Docket Item #4
BZA #2024-00002
Board of Zoning Appeals
July 8, 2024

ADDRESS: 401 Jackson Place
ZONE: R-8/Residential zone
APPLICANT: Karen Becker, Architect

ISSUE: Special exception to construct a two-story addition in the required side yard.

Figure 1: Site plan of proposed addition

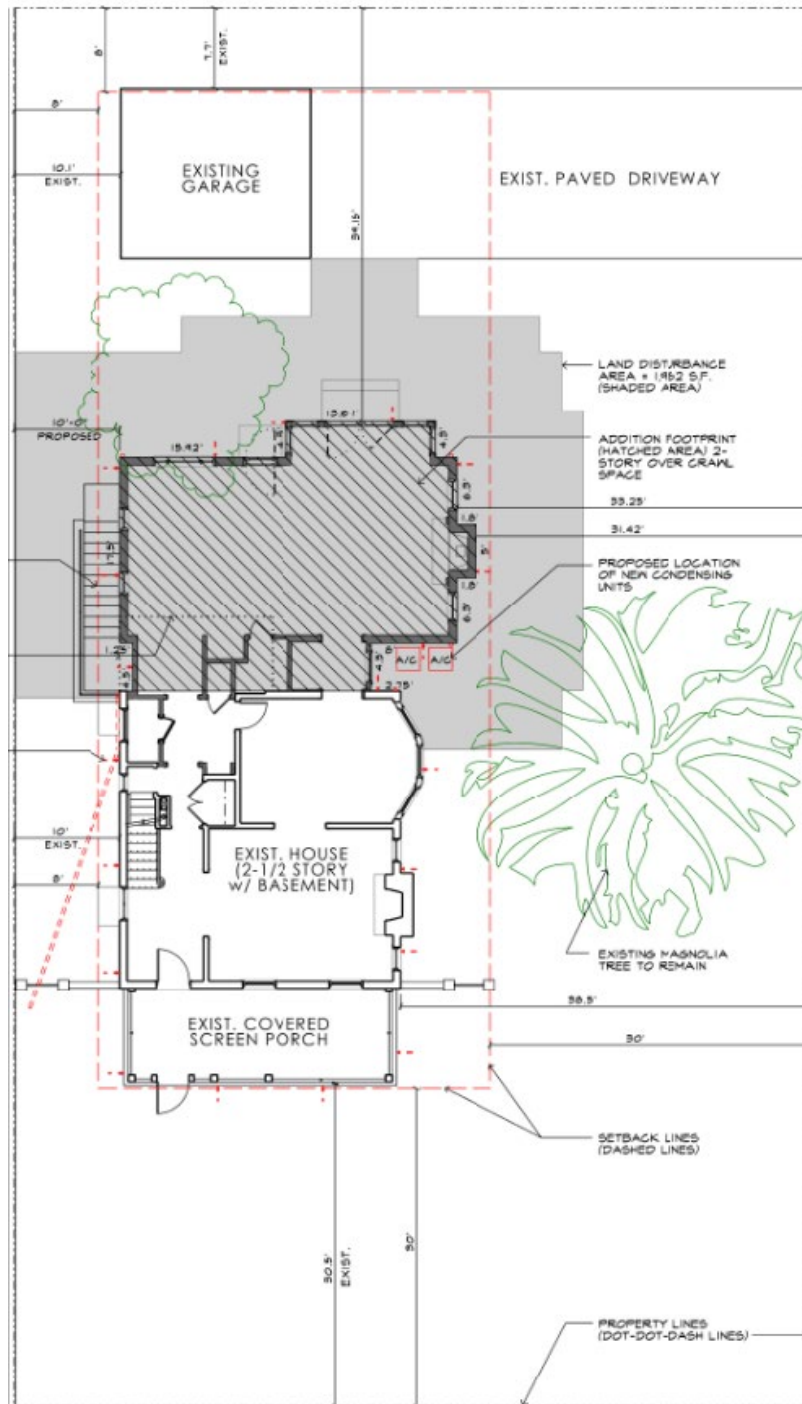
The applicant requests a special exception of 0.69 feet from the required 10.69-foot side yard setback requirement to construct a two-story addition 10.00 feet from the northwest side property line in line with the existing noncomplying side wall of the dwelling.

The addition could be reconfigured or reduced to comply with all setbacks. Since the addition is not being built above an existing one-story structure, there is more flexibility to design an addition that is in compliance. The plans show there is a portion of the proposed addition where the stair entrance is located that is already setback enough to comply. The rest of the addition could align with this portion and comply with the zoning ordinance. The proposed addition could be reduced in height or reduced 0.69 feet on the side to meet the required setback ratio.
